Access Compliance Report

Public Rights-of-Way

Intersection ID: 14720	Main Street: E_5TH_ST	Cross Street: N_DOTGER_AV	Location: W
ADA ID: 42AB42FBC023	Ramp Type: Directional1	Initial Pass/Fail: Fail	Overall Compliance: No
		Severity Score: 12.5

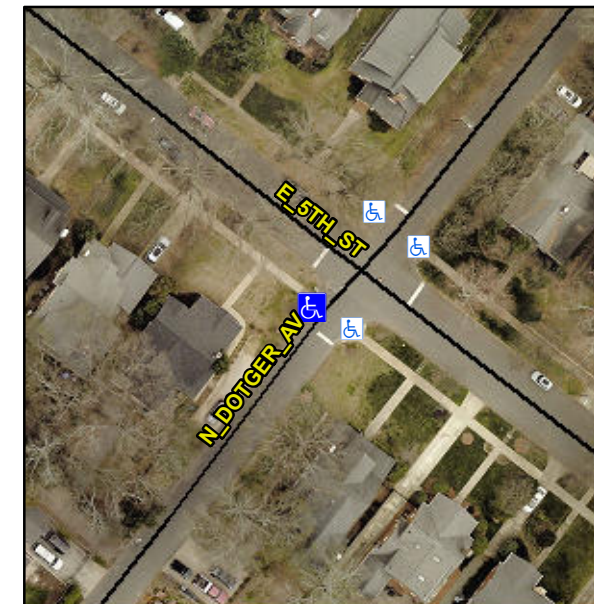
Compliance	Description	Data	Compliance	Description	Data
N/A	Ramp Length (in)	364.0	N/A	Grade Break?	N/A
Yes	Ramp Width (in)	59.0	N/A	Grade Break Slope (%)	0.0
Yes	Ramp Slope (%)	9.5	N/A	Grade Break XSlope (%)	0.0
Yes	Ramp XSlope (%)	0.6			
N/A	Flare Type LT	N/A	N/A	Flare Type RT	N/A
N/A	Flare Slope LT (%)	N/A	N/A	Flare Slope RT (%)	0.0
N/A	Flare Traversable LT?	N/A	N/A	Flare Traversable RT?	N/A
N/A	Landing Length (in)	0.0	N/A	DWS Provided?	N/A
N/A	Landing Width (in)	0.0	N/A	DWS Contrast?	N/A
N/A	Landing Slope (%)	0.0	N/A	DWS Length (in)	N/A
N/A	Landing X Slope (%)	0.0	N/A	DWS Full Width?	N/A
N/A	Landing Curb? (Y/N)	N/A	N/A	DWS Offset LT (in)	N/A
N/A	Shared Landing?	N/A	N/A	DWS Offset RT (in)	N/A
N/A	Gutter Ponding?	0.0	N/A	Gutter Slope (%)	N/A
N/A	Gutter Lip Ht (in)	0.0	N/A	Gutter X Slope (%)	N/A
N/A	Painted X Walk1?	No		Road Slope (%)	0.3
	X Walk 1 Direction	To SE		Road X Slope (%)	1.7
	X Walk 1 Width (in)	N/A		Clear Space?	N/A

X Walk 1 Slope (%)	0.3	N/A	Clear Space to XWalk (in)	N/A
	X Walk 1 X Slope (%)	1.7	N/A	Storm Grate/Utility Hazard?	N/A
N/A	Ramp inside XWalk1?	N/A		Storm Grate/Utility Type	
N/A	Any Obstructions?	N/A			N/A
	Obstruction Type		Yes	Surface Condition? (G/P)	Good
			N/A	Curb Slope (%)	5.8

Remove & Replace Entire Ramp.
